BID ADDENDUM #3

DATE: December 11, 2023
PROJECT: 10th St Bridge Multi-modal Connection Project
PROJECT P.I. NO. 0015890
NUMBER:

Change to Contract Drawings

7 COA FIXTURE CONCRETE FOUNDATION DETAIL
25-2002 N.T.S.

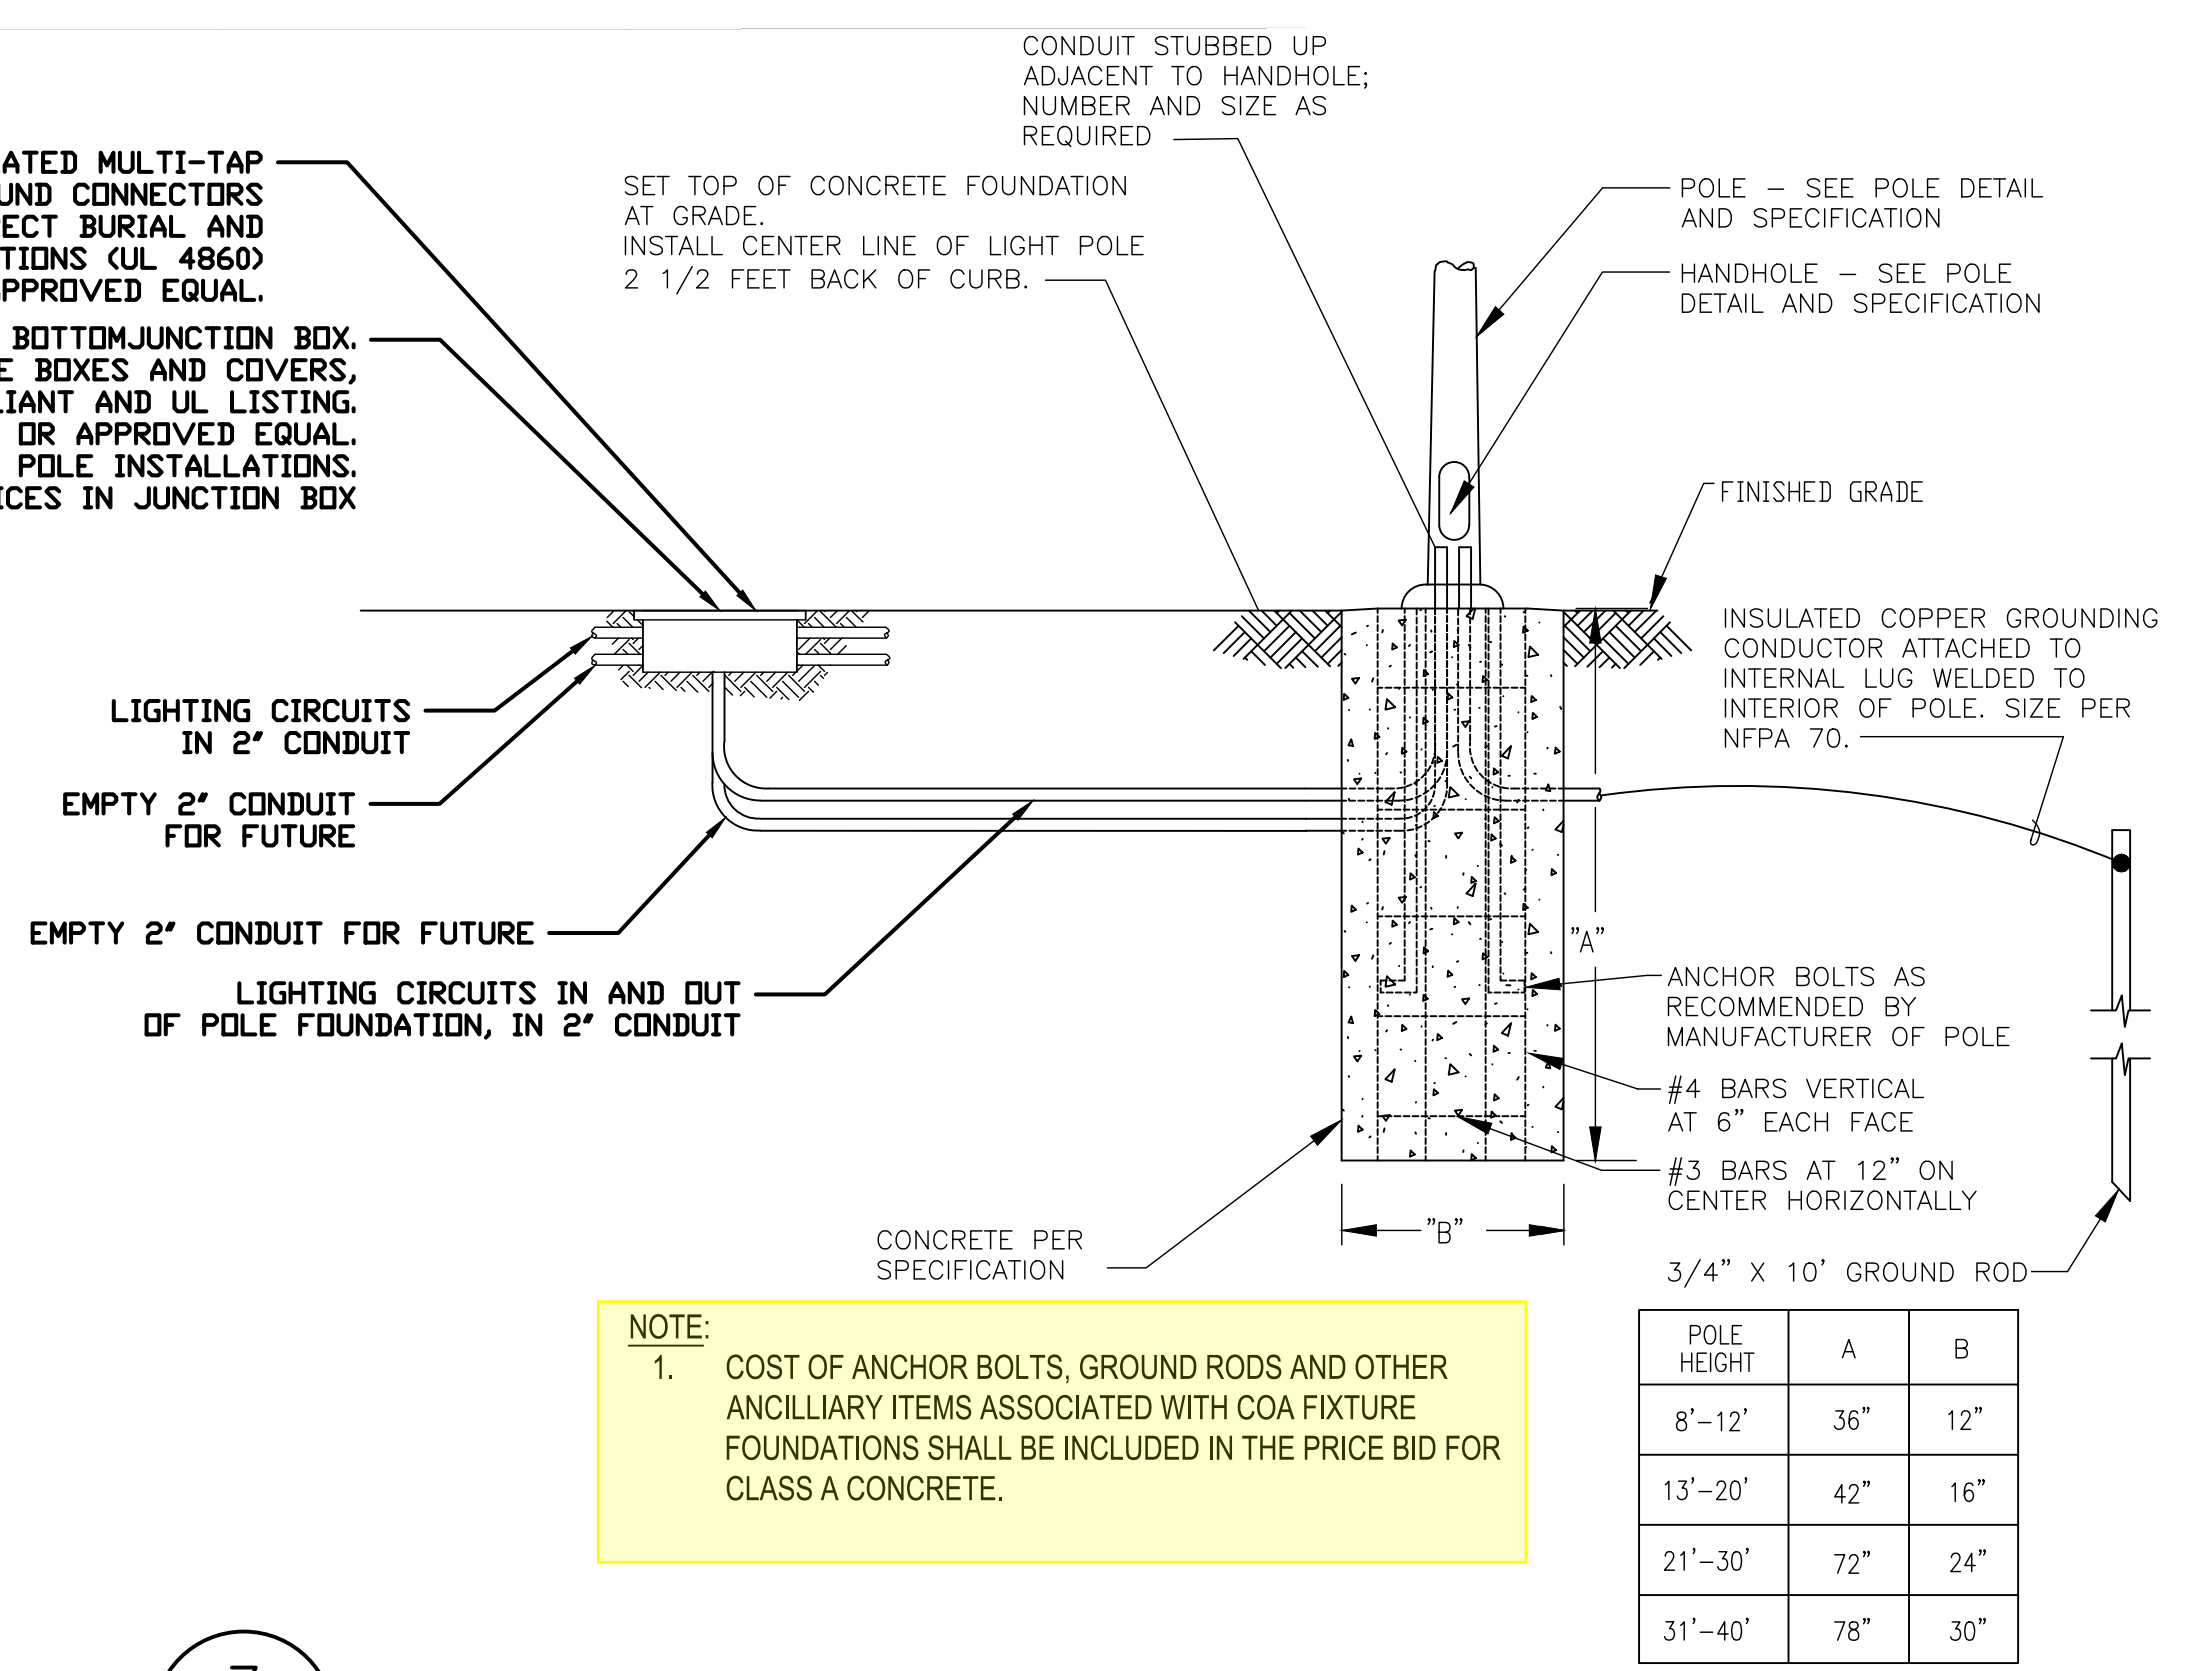
1. Sheet 25-2002 - A note was to the COA light fixture foundation detail indicating ancillary items (anchor bolts, ground rods, etc.) are to be included in the price bid for Class A concrete. See attached plan sheet.
2. Sheet 25-2005 – A note was added indicating the quantity of concrete and steel required for each COA standard light fixture foundation. See attached plan sheet.
3. Sheet 25-2007 - A note was added indicating roadway light circuits (i.e. City of Atlanta standard light fixture circuits) are not to be installed in the meter pedestals. See attached plan sheet.

- COST OF ANCHOR BOLTS, GROUND RODS AND OTHER ANCLLIARY ITEMS ASSOCIATED WITH COA FIXTURE FOUNDATIONS SHALL BE INCLUDED IN THE PRICE BID FOR CLASS A CONCRETE.
